Wonarah Phosphate Project

Environmental Impact Statement Supplement

ENVIRONMENTAL IMPACT STATEMENT SUPPLEMENT

Figure No:
3.2

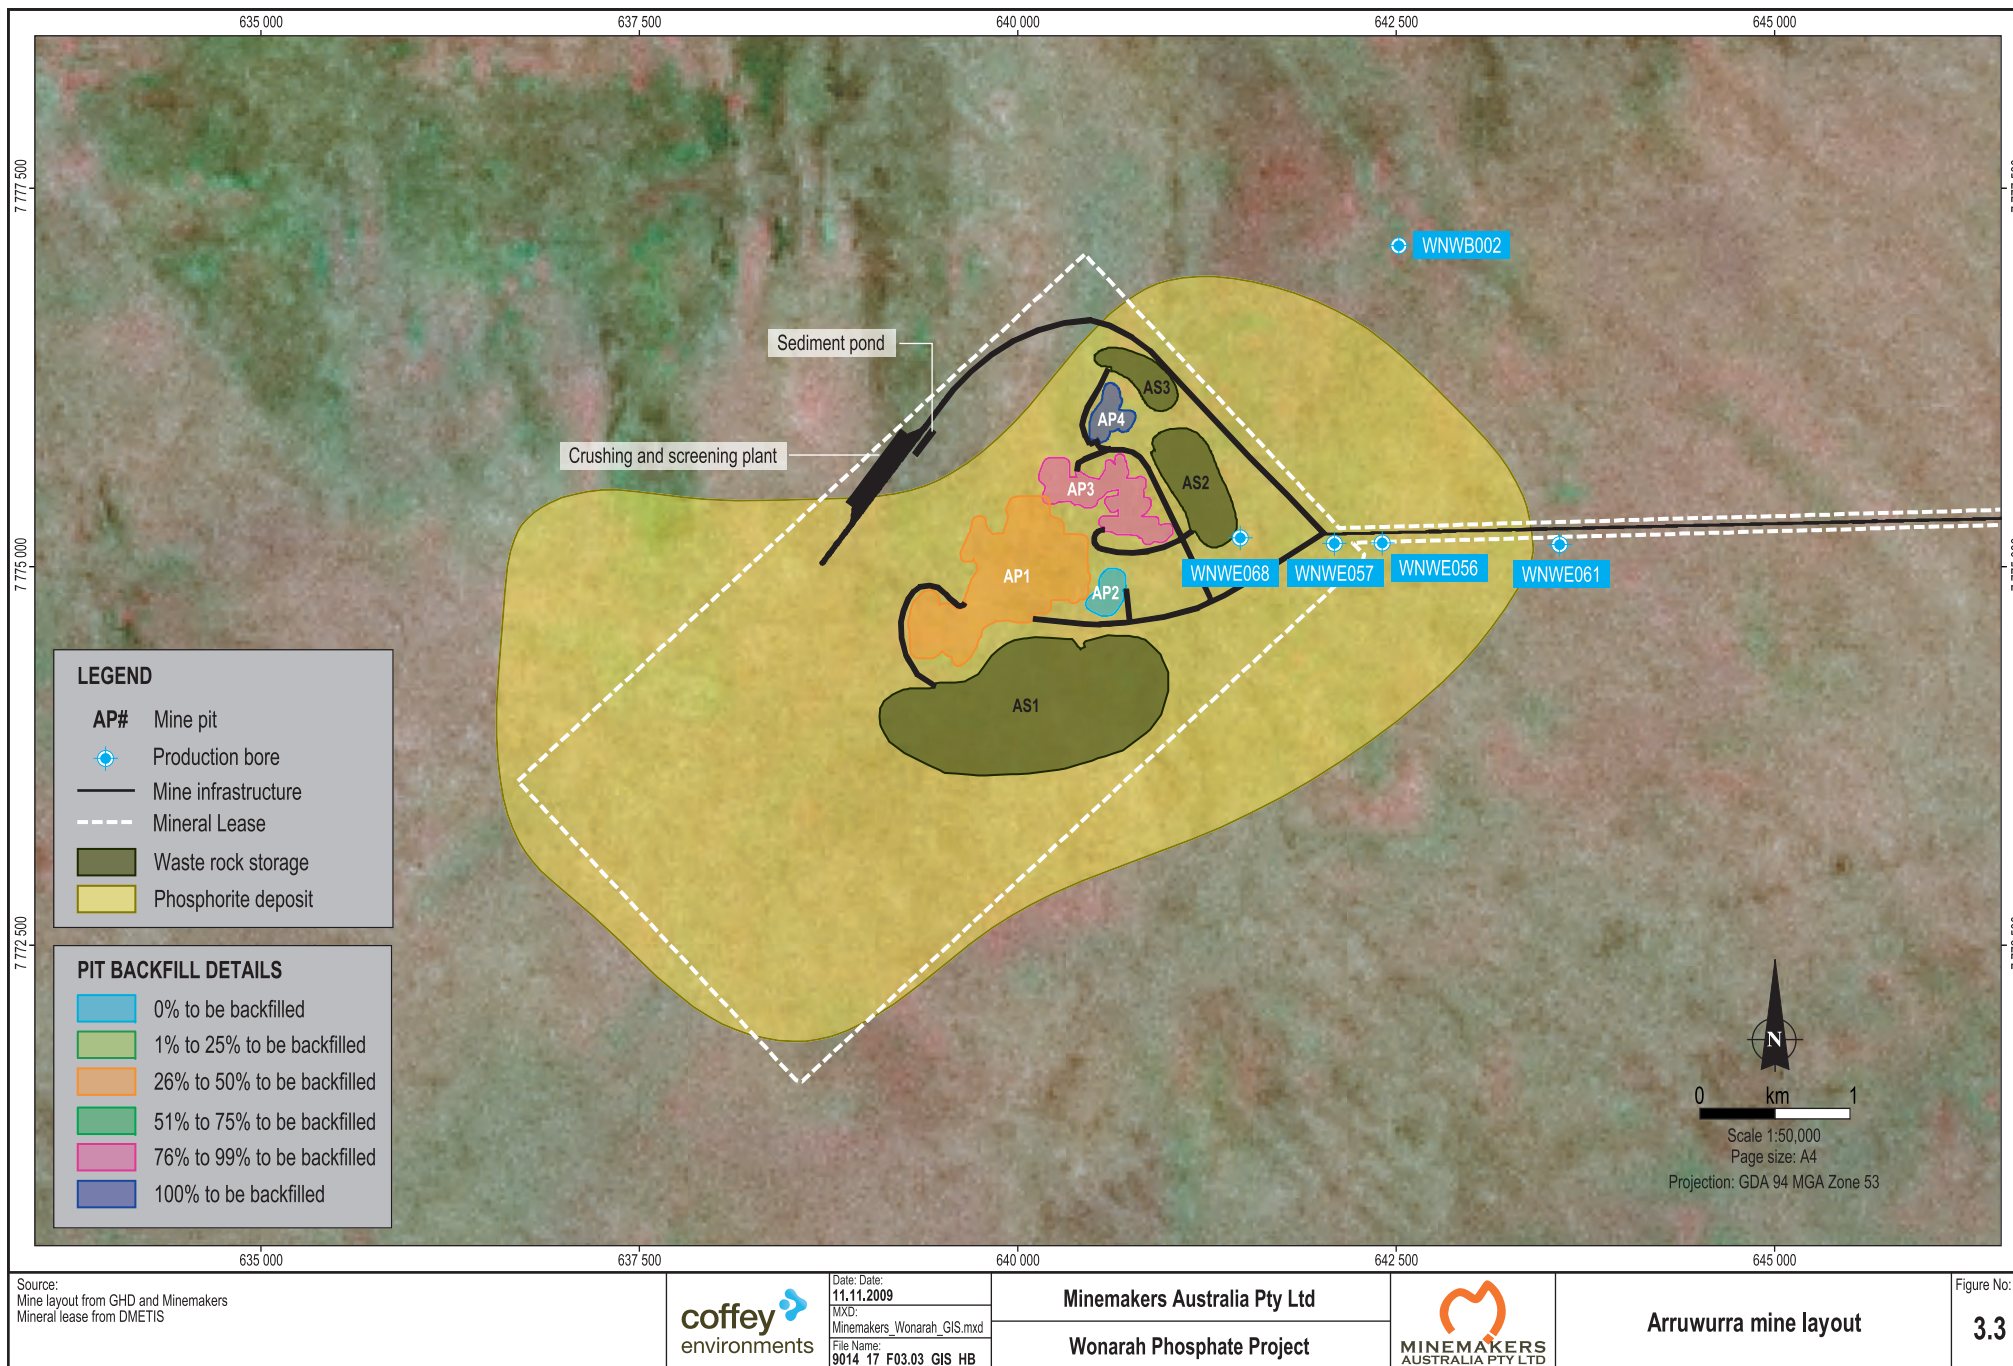
Response

Figures 5.2 and 5.3 of the Draft EIS have been amended to show which pits will be backfilled and the percentage of backfilling proposed. These are presented as Figures 3.2 and 3.3, below.

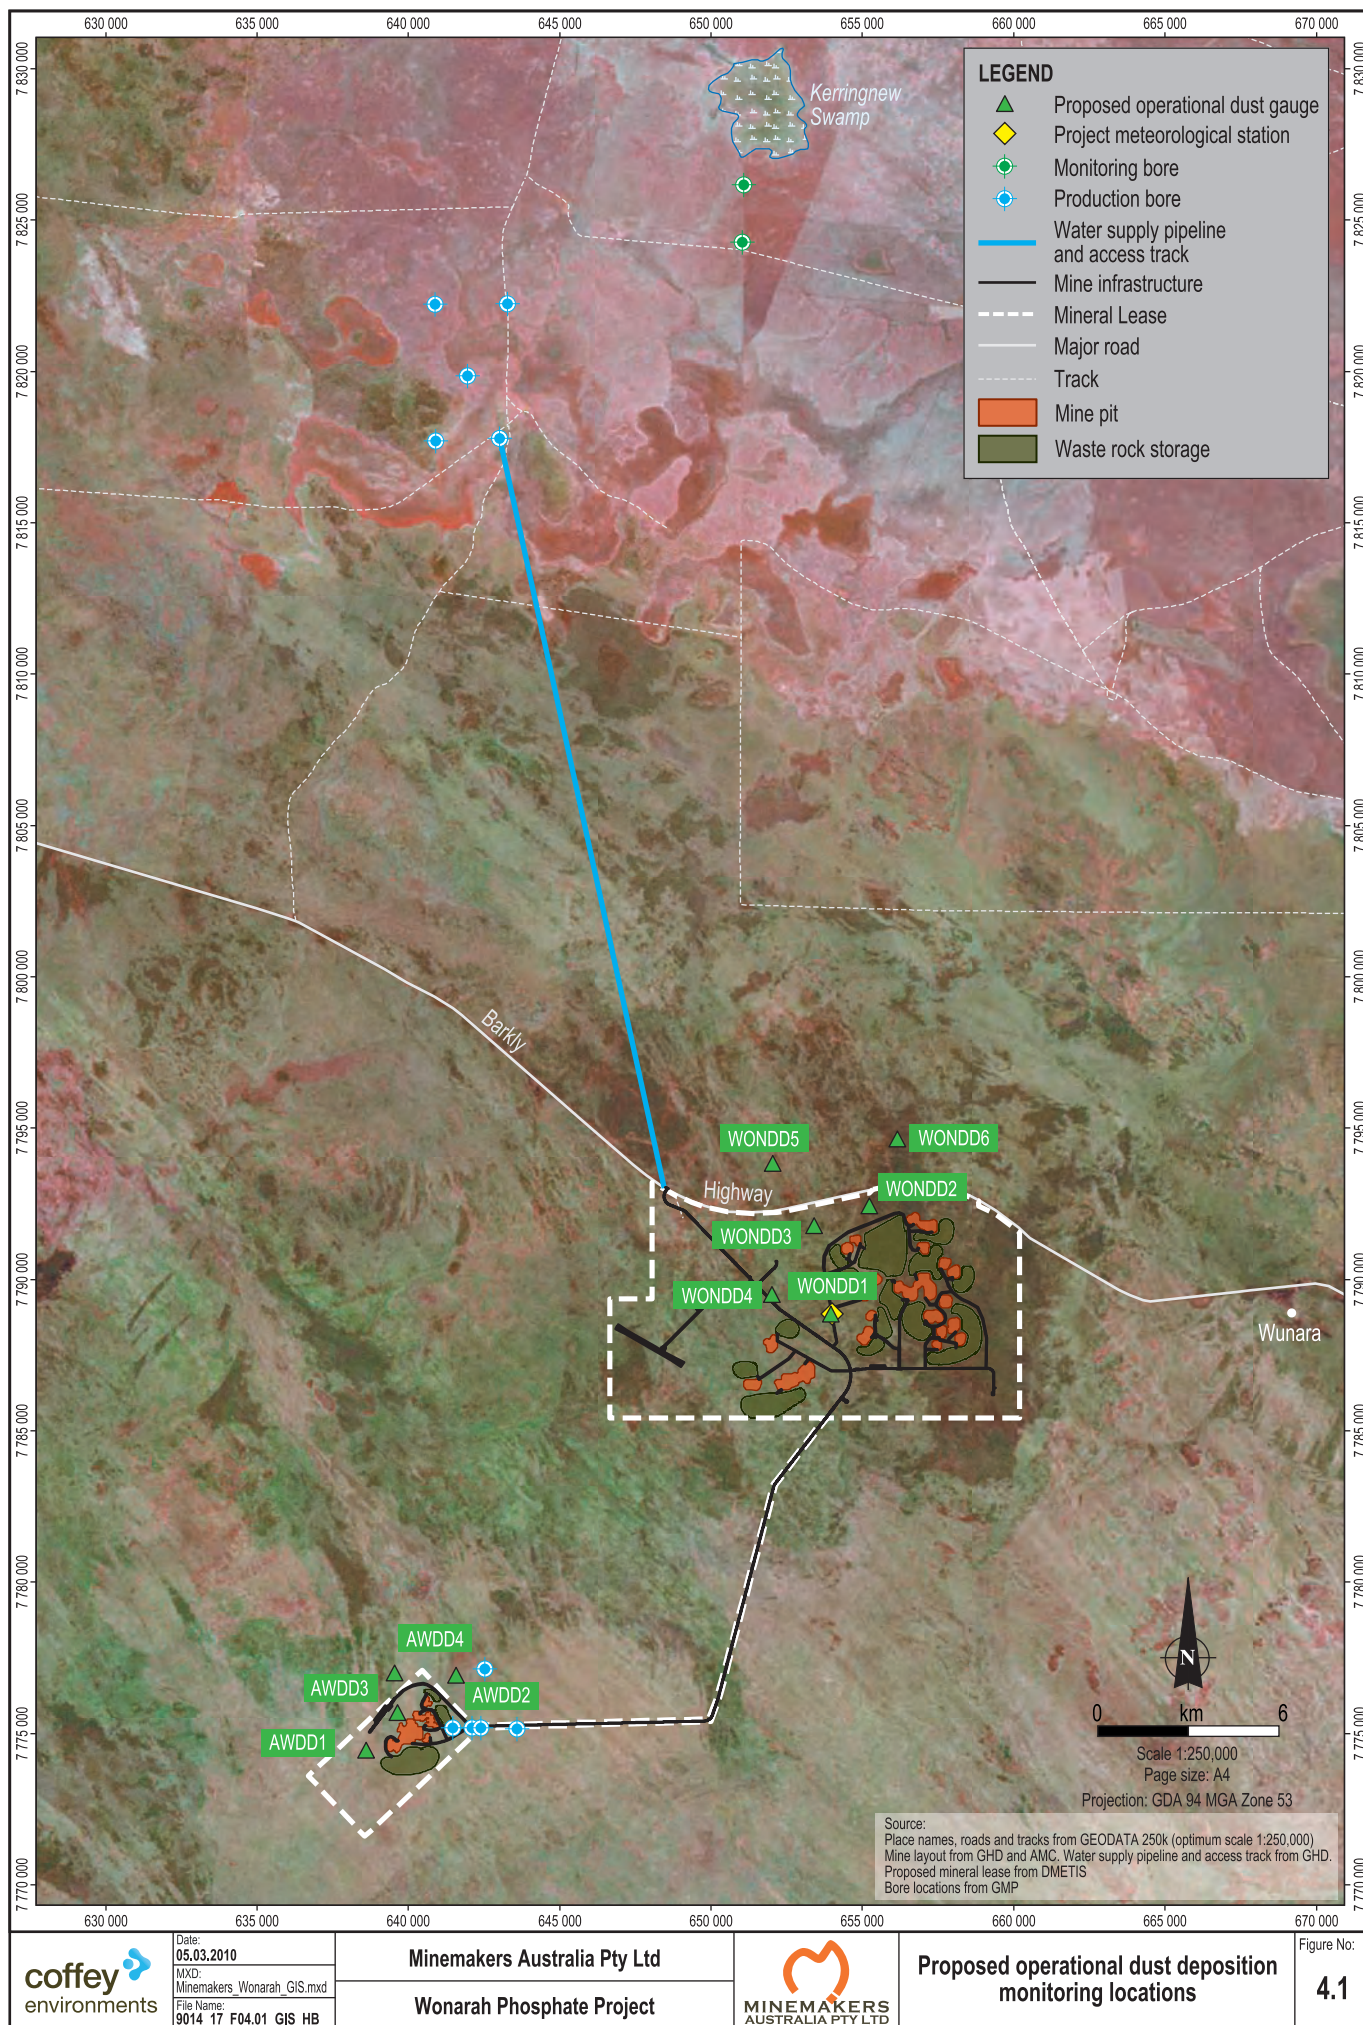
One of the submissions received highlighted that with the exception of dust gauges WONDD1 and WONDD4, the other six dust monitoring gauges were upwind (based on prevailing wind directions) of most activities (see Figure 6.2 of the Draft EIS). The submission requested that sampling locations be justified with reference to Australian Standards and that a dust gauge closer to the road be considered, to measure the potential effects of dust on highway travellers.

These existing dust gauges will be moved to new locations based on the mine plan. Figure 4.1 shows the proposed operational dust gauge locations, including two additional dust gauges that will be located north of the Barkly Highway to monitor any potential the dust movement across the highway from the Mineral Lease. As per the Australian Standard, the new location of dust gauges and the reason for the changed location will be recorded in the dust monitoring records for the site. Once installed at their new locations, Minemakers will supply details of their location to DNRETAS.

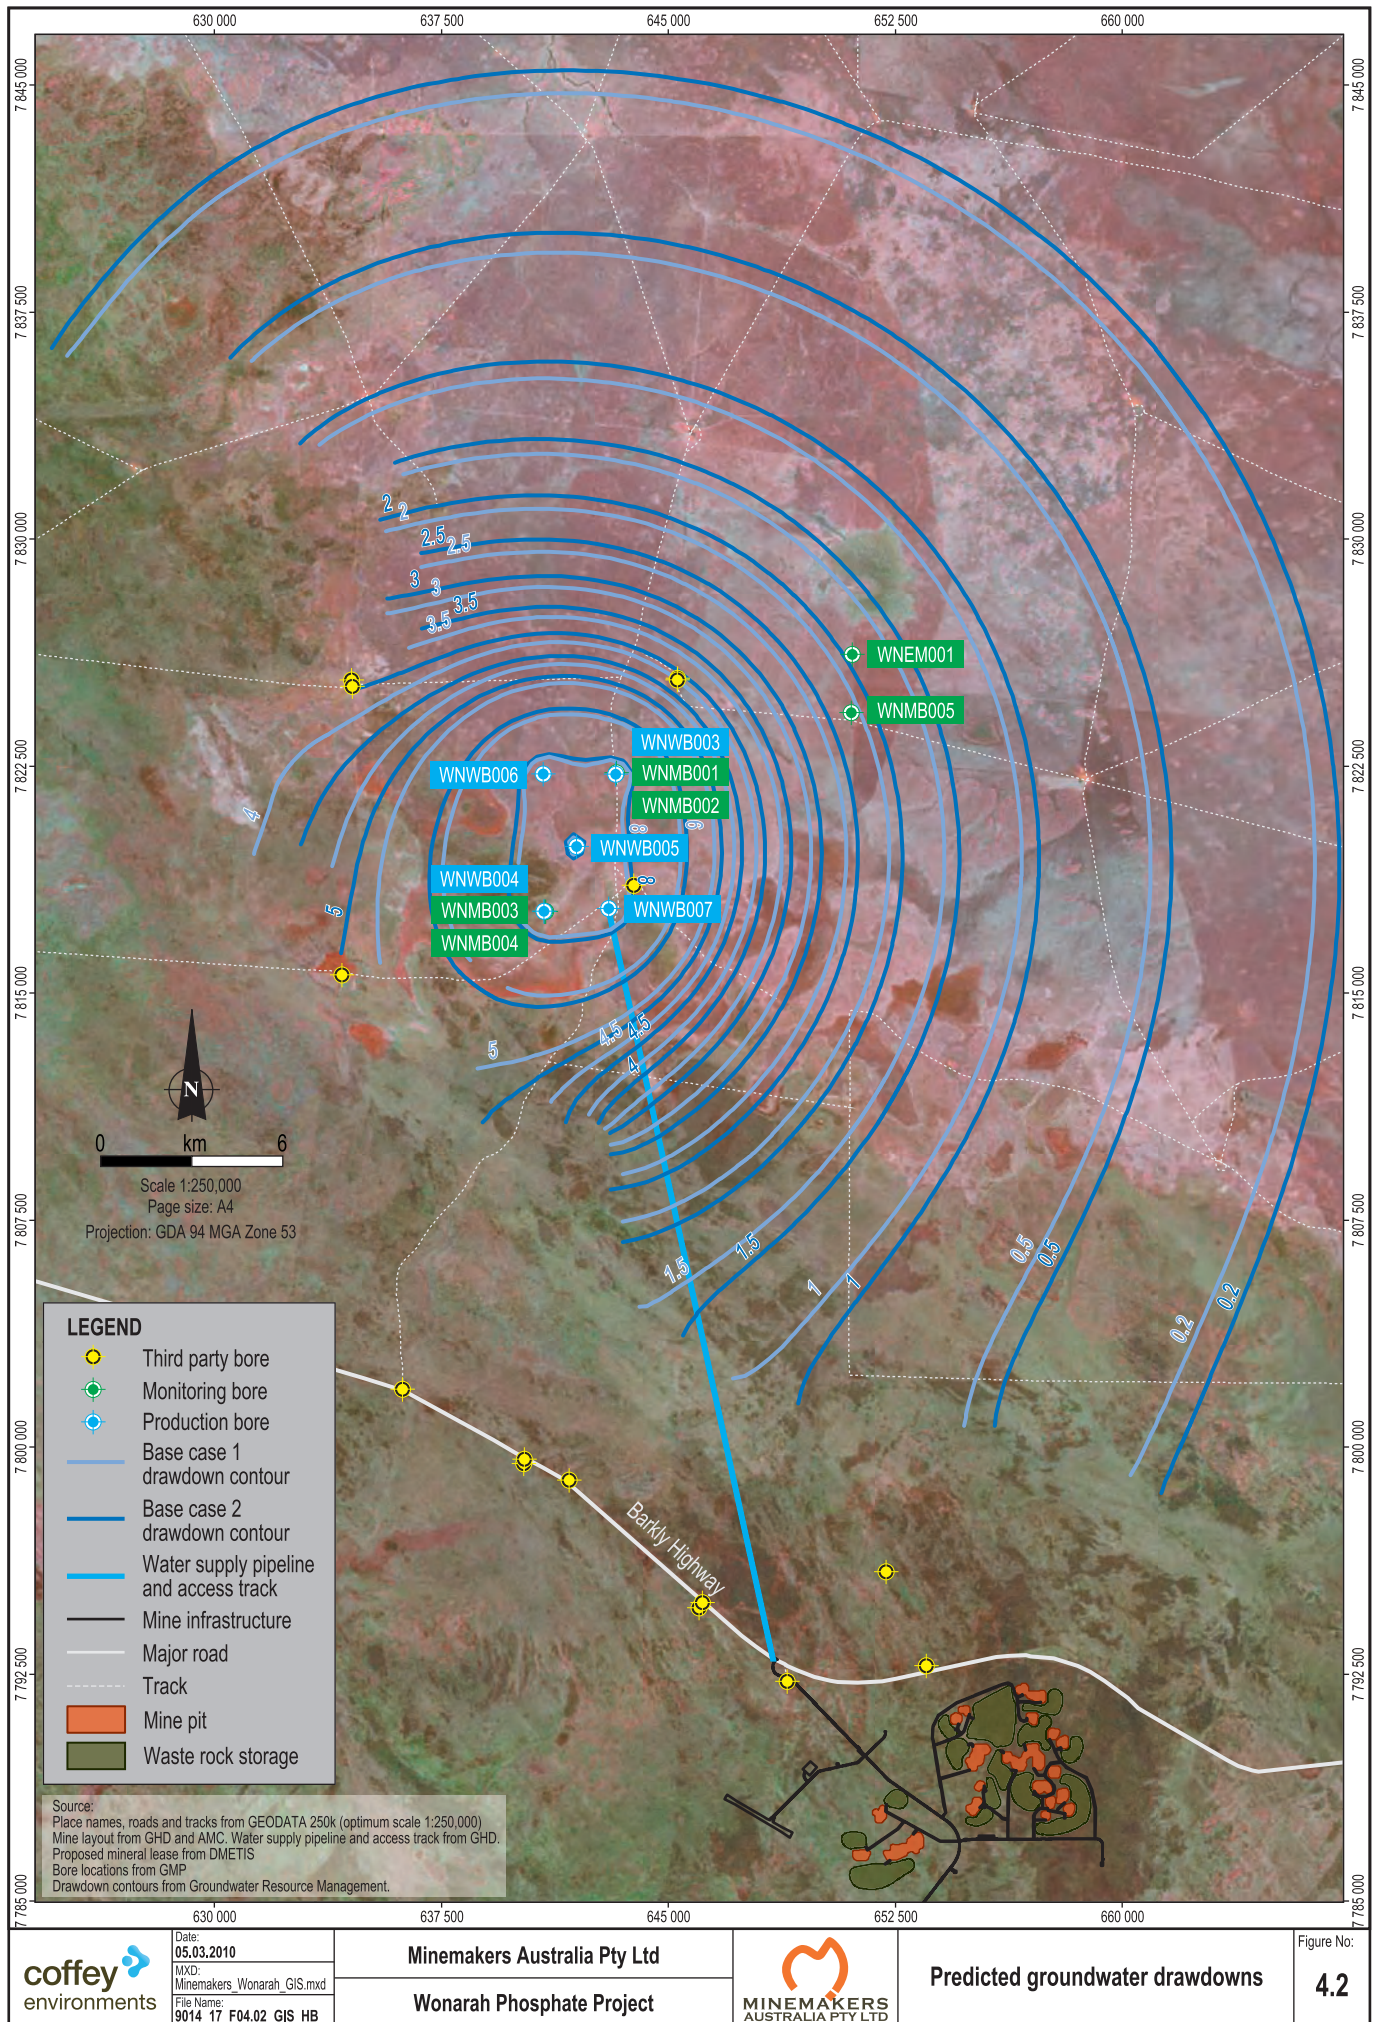
One submission requested that third party user bores and the Wunara community bore be added to Figure 6.10 of the Draft EIS.

Minemakers acknowledges the request to amend Figure 6.10 to include third party bores; the revised figure is included as Figure 4.2. The location of the Wunara community bore is not shown on this figure, as it is outside the limit of the figure and approximately 12.5 km southeast from the boundary of the lowest level (0.2 m) of predicted groundwater drawdown.
